Access Compliance Report Public Rights-of-Way (Curb Ramps)

Main Street: KEMPTON_DR Cross Street: SILVER_FOX_RD Location: NW

ADA ID: RPRK211208124451 Ramp Type: Type 1 - Perpendicular Diagonal Initial Pass/Fail: Pass Overall Compliance: No Severity Score: 10

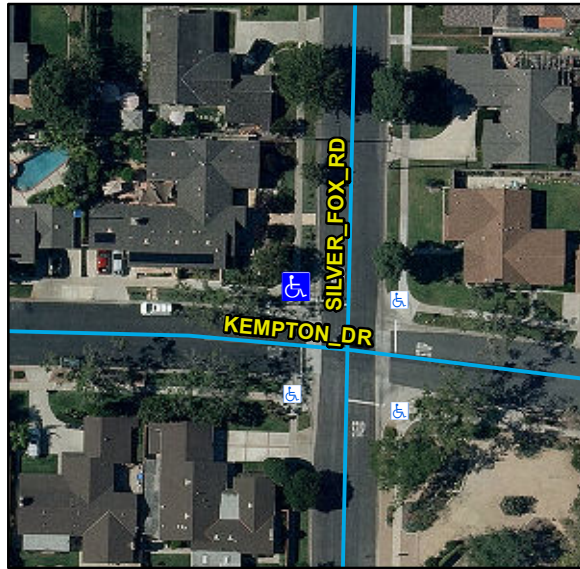
Compliance	Description	Data	Compliance	Description	Data
N/A	Ramp Length (in)	83	N/A	Flare Type LT	
Yes	Ramp Width (in)	48			Sloped
Yes	Ramp Run Slope (%)	5.5	N/A	Flare Slope LT (%)	2.6
Yes	Ramp Cross Slope (%)	1	N/A	Flare Traversable LT	No
N/A	Landing Present	Yes	N/A	Flare Type RT	
N/A	Landing Length (in)	48			Sloped
Yes	Landing Width (in)	48	N/A	Flare Slope RT (%)	7.5
Yes	Landing Run Slope (%)	0.3	N/A	Flare Traversable RT	No
Yes	Landing Cross Slope (%)	1	No	DWS Provided	No
N/A	Landing Movement Obstructed?	No	N/A	DWS Contrast	N/A
	Landing Movement Type	N/A	N/A	DWS Length (in)	N/A
N/A	Landing Shared	No	N/A	DWS Full Width	N/A
N/A	Clear Space	Yes	N/A	DWS Offset Left (in)	N/A
N/A	Clear Space To Crosswalk (in)	48	N/A	DWS Offset Right (in)	N/A
N/A	Marked Crosswalk 1	No	N/A	Marked Crosswalk 2	No
	Crossing 1 Direction	S		Crossing 2 Direction	E
	Marked Crosswalk 1 Width (in)	N/A		Marked Crosswalk 2 Width (in)	N/A
N/A	Ramp Inside Crosswalk 1	N/A	Yes	Ramp Inside Crosswalk 2	N/A

Crossing 1 Slope (%)	5.2		Crossing 2 Slope (%)	5
	Crossing 1 Cross Slope (%)	2.6		Crossing 2 Cross Slope (%)	2.8
Yes	Gutter Ponding	No	Yes	Curb Slope	2.3
Yes	Gutter Lip Height (in)	0		Road Run Slope (%)	1.7
Yes	Gutter Run Slope (%)	2.9		Road Cross Slope (%)	1.7
No	Gutter Cross Slope (%)	2.8			
Yes	Overall Surface Condition: Acceptable		No	Perp Joint Present	No
	Cross Gutter Present?	Yes		Spandrel Present?	Yes
	Replace Cross Gutter?	No		Replace Spandrel?	No

Remove & Replace Curb Ramp With Two New Directional Ramps or Equivalent. Remove & Replace Gutter.
